CITY OF COLORADO SPRINGS

RE: Neal Ranch Master Plan; CPC MP 80-16-A9(88)

RE: Neal Ranch Master Plan; CPC MP 80-16-A8(87)

FIGURE 2

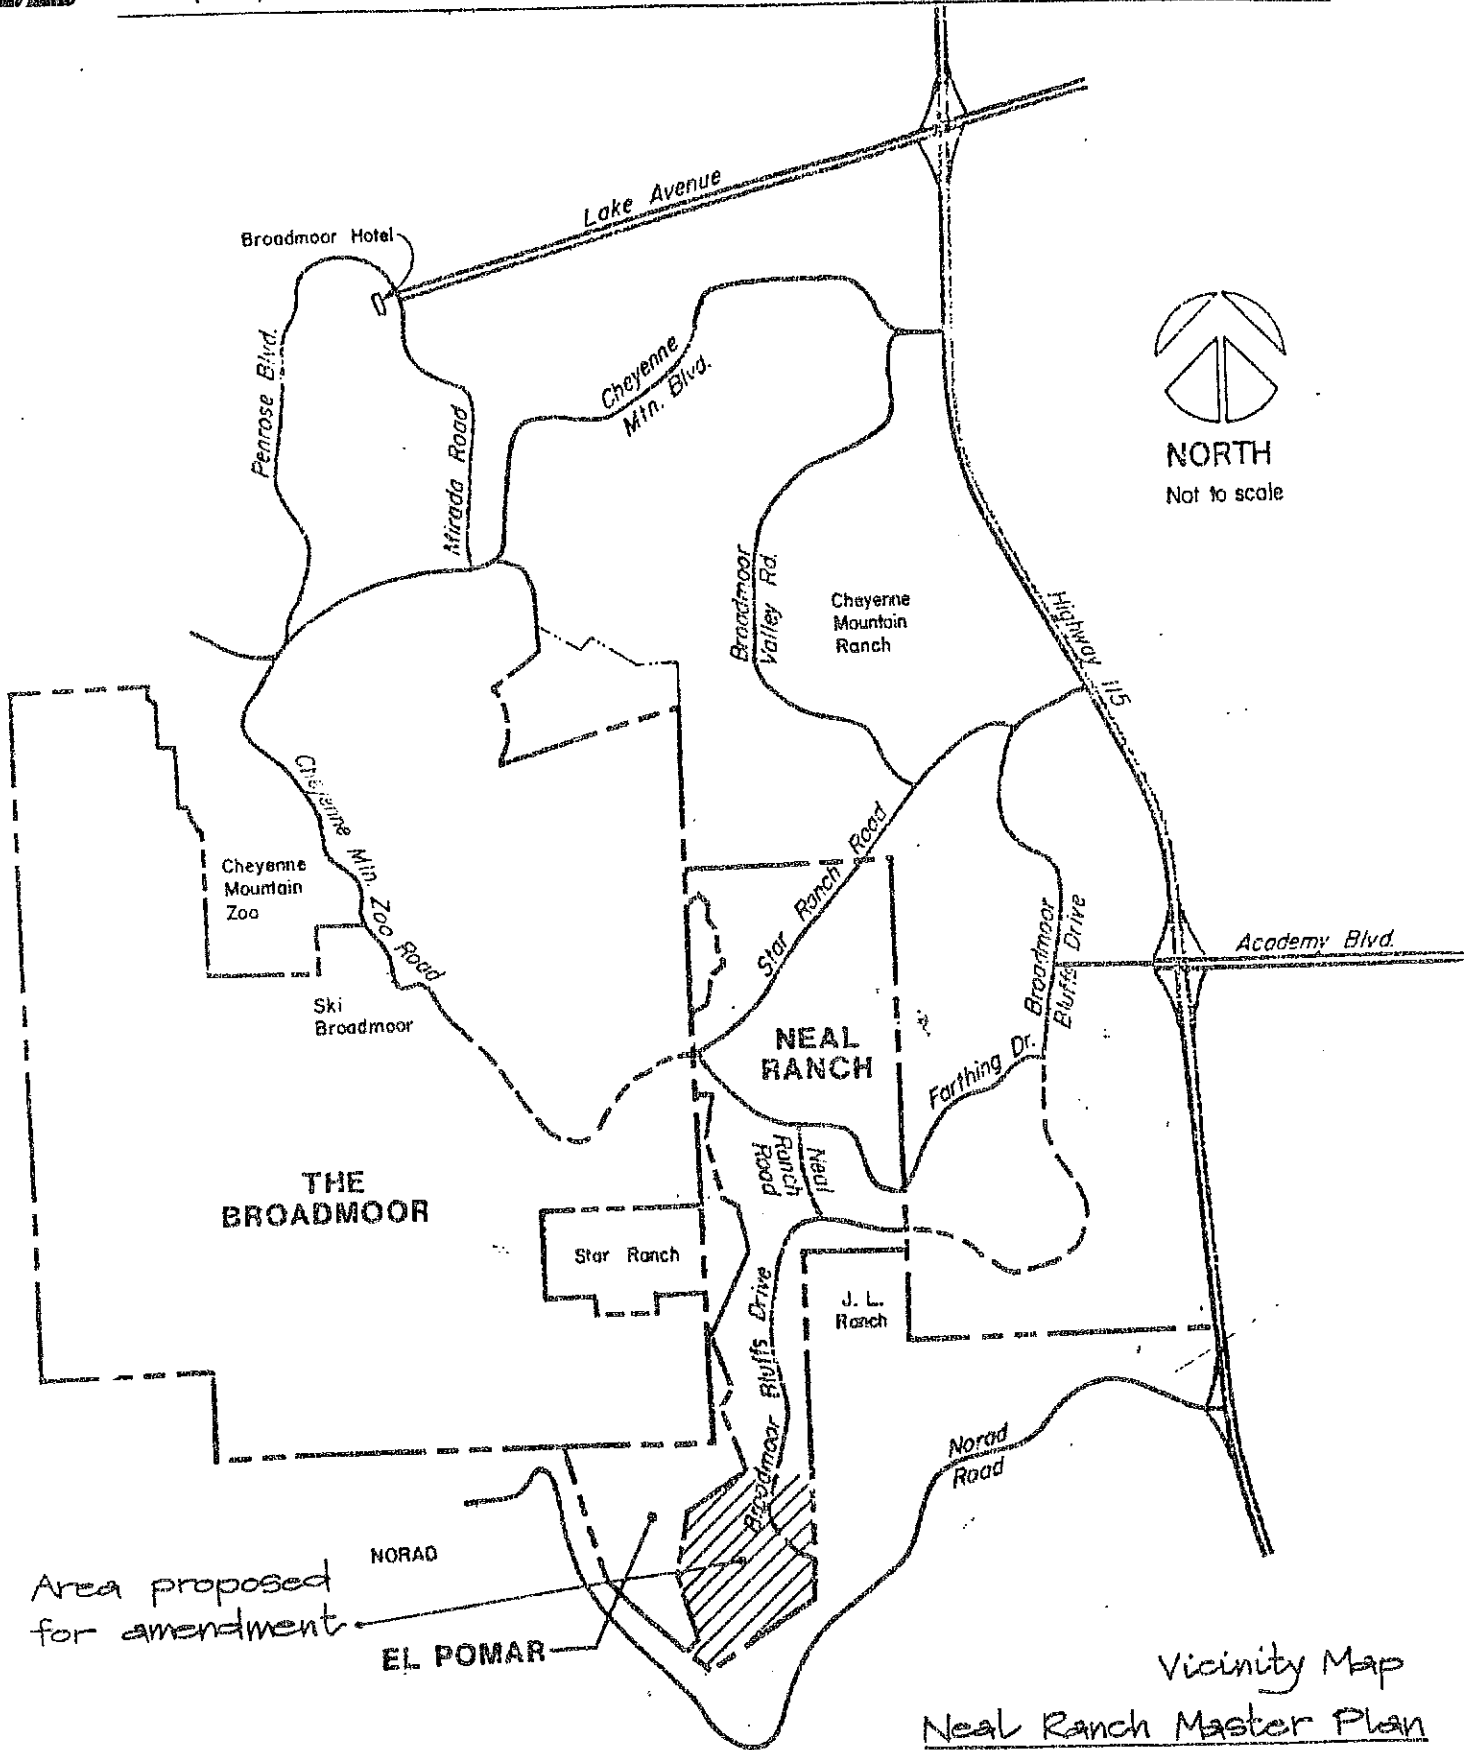
Overview: These requests involve amendments to the Broadmoor Master Plan, the Neal Ranch Master Plan, and the El Pomar Master Plan. The areas which are proposed to be amended are illustrated in FIGURES 1, 2, and 3.

FIGURE 5

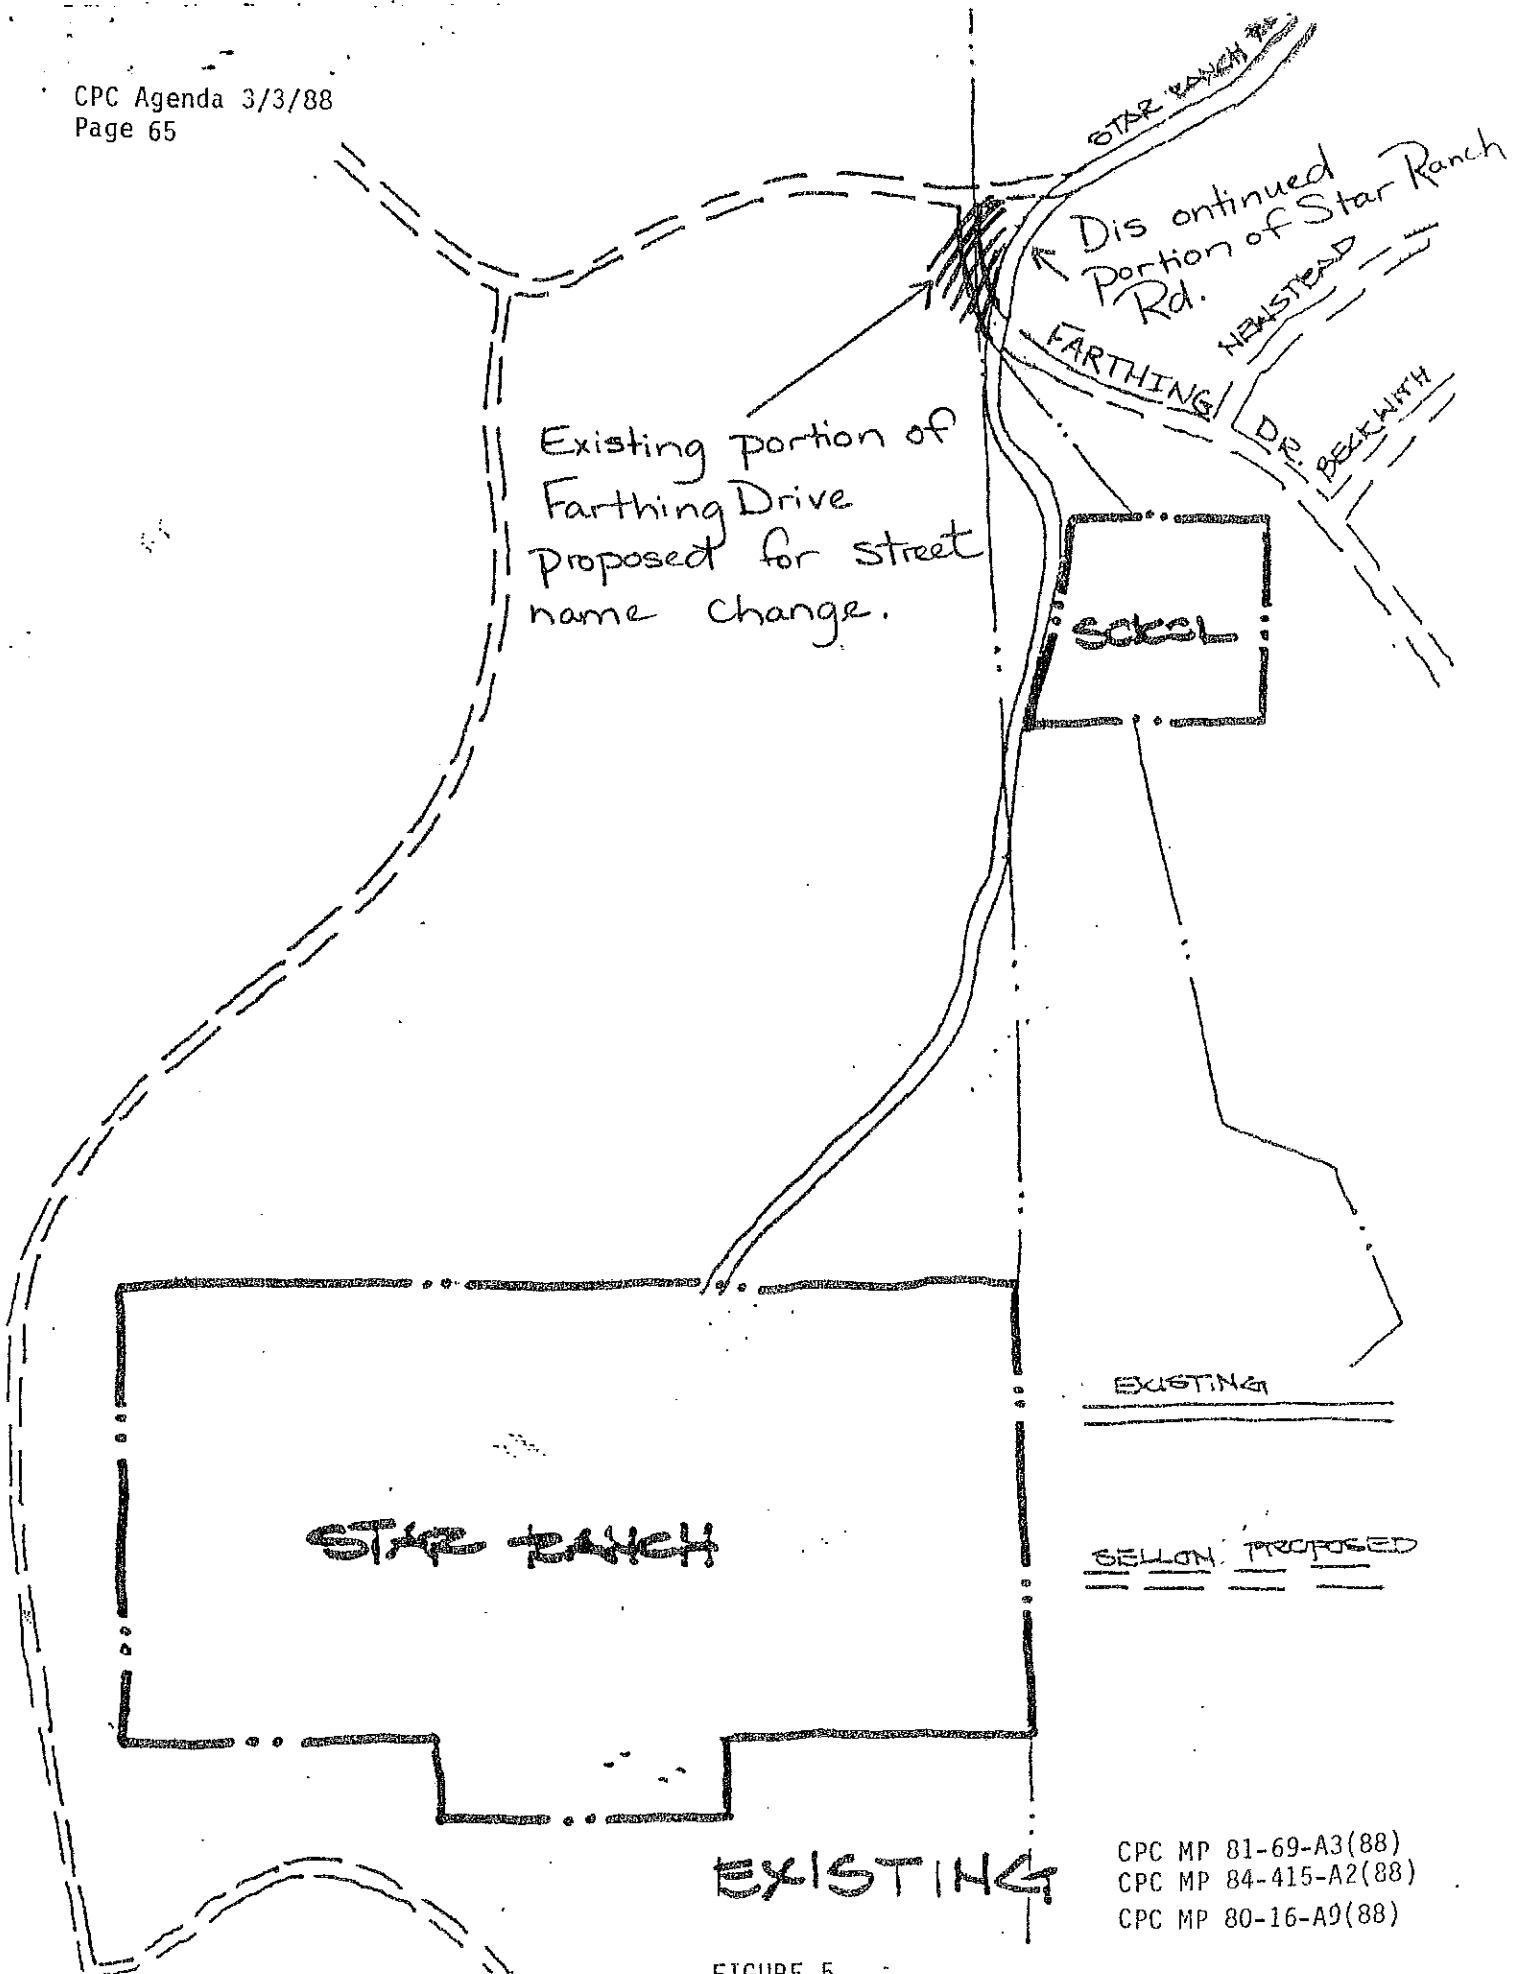
FIGURE 5 shows the existing alignment of Star Ranch Road and Farthing Drive. The area proposed for a street name change is identified. This proposal would mean that Farthing Drive would change names at some nebulous point in the middle of the street. It should be noted that the Planning Division will not support a street name change for this stretch of Farthing Drive because of the awkward alignment and the confusion associated with changing street names at a point other than a street intersection.

FIGURE 7

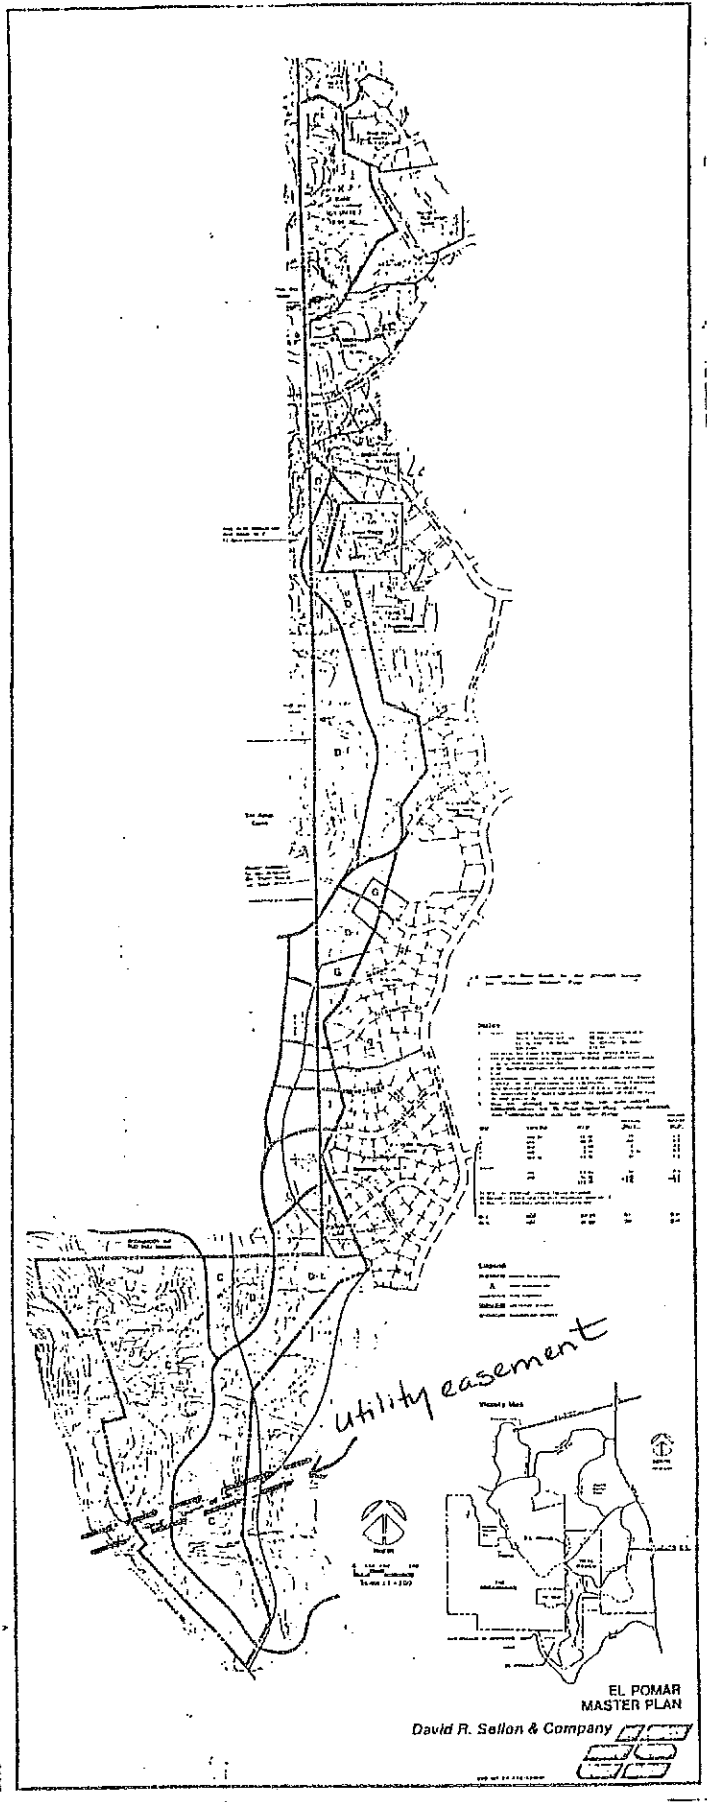
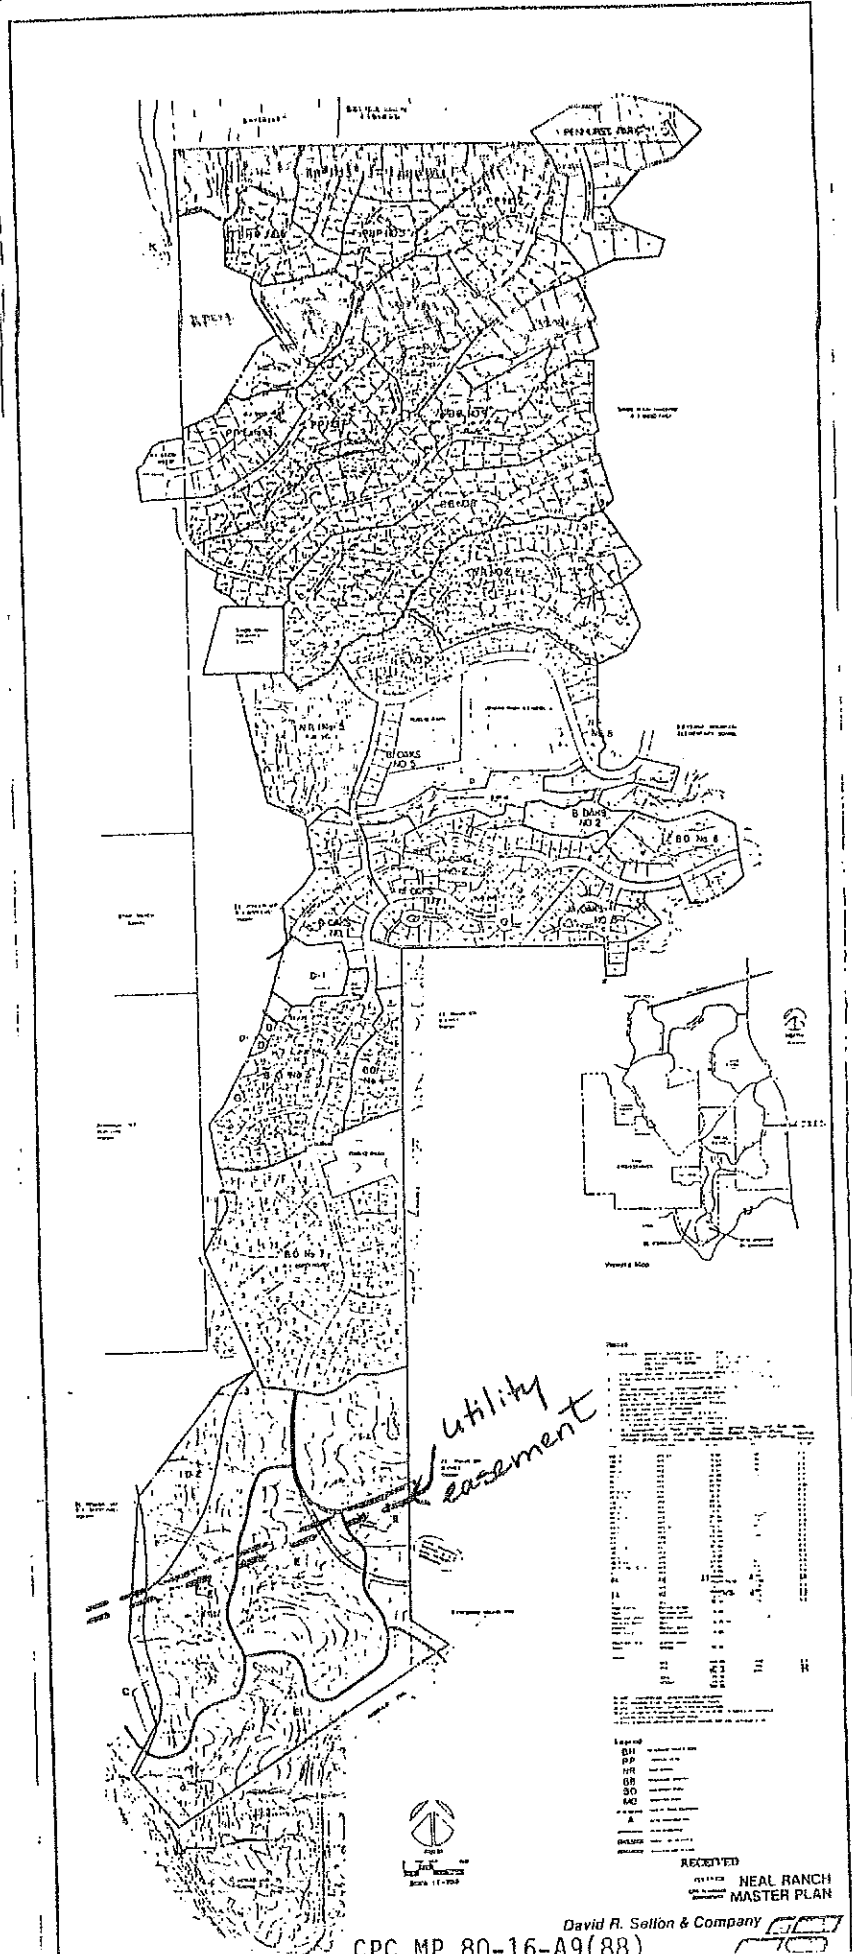
Technical Changes to Be Made to the Broadmoor/El Pomar/Neal Ranch Master Plans:
The following changes must be made to the Broadmoor/El Pomar/Neal Ranch Master Plans in order to demonstrate a community benefit:

1. A Phasing Plan should be provided for each master plan in order to determine the construction schedule of streets and public facilities. This is especially necessary in order to address the concerns of the Broadmoor Oaks neighborhood with regard to construction traffic.
2. Please include the following note on the Neal Ranch Master Plan and the El Pomar Master Plan:

"Subsequent to the submittal to the City of any future preliminary plats, the Air Force reserves the right to review and comment on any development, including utilities and infrastructure, that is proposed adjacent to or traverses the NORAD utility easement."
3. Please provide a six foot (6') high solid wood fence along the southern property lines of the Neal Ranch Master Plan and the El Pomar Master Plan as requested by the Air Force for security at the NORAD facility.
4. The applicant has already submitted revised master plans which address the following issues:
 - A. Public and emergency access to Star Ranch,
 - B. The "T" intersection at Stanwell Street and the north/south collector,
 - C. Street and utility crossings of the NORAD easement, and
 - D. Acreage breakdowns for some of the larger residential parcels.

These changes are acceptable and should be shown on the revised plans (FIGURES 7, 8, and 9).
